Advanced Heart, Lung and Vascular Care

RE: License Number 29-31231-01

This letter is sent to request the following amendments to our radioactive materials license, number ~~29-18190-01~~. ~~29-31231-01~~

PLAN REVISION NO. 4

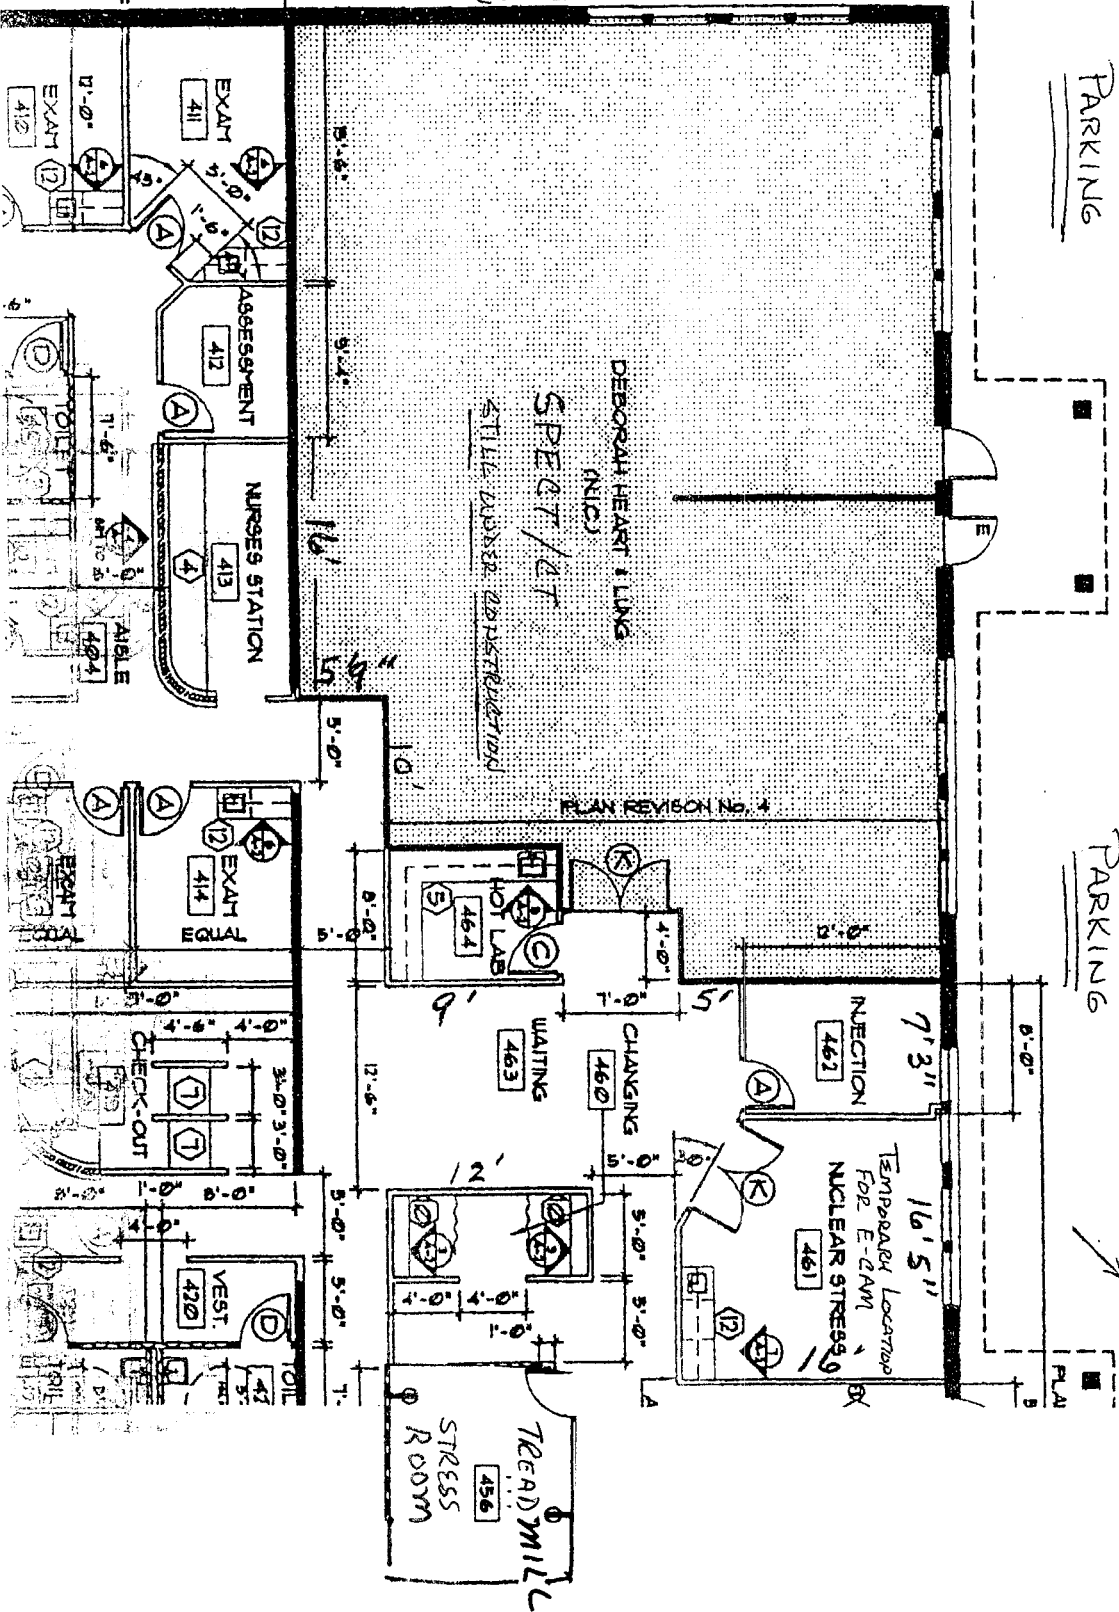
The treadmill has been moved to a separate location across the hall from the camera imaging room. Appropriate signage and monitoring of these and all other rooms will occur. A updated diagram is enclosed.
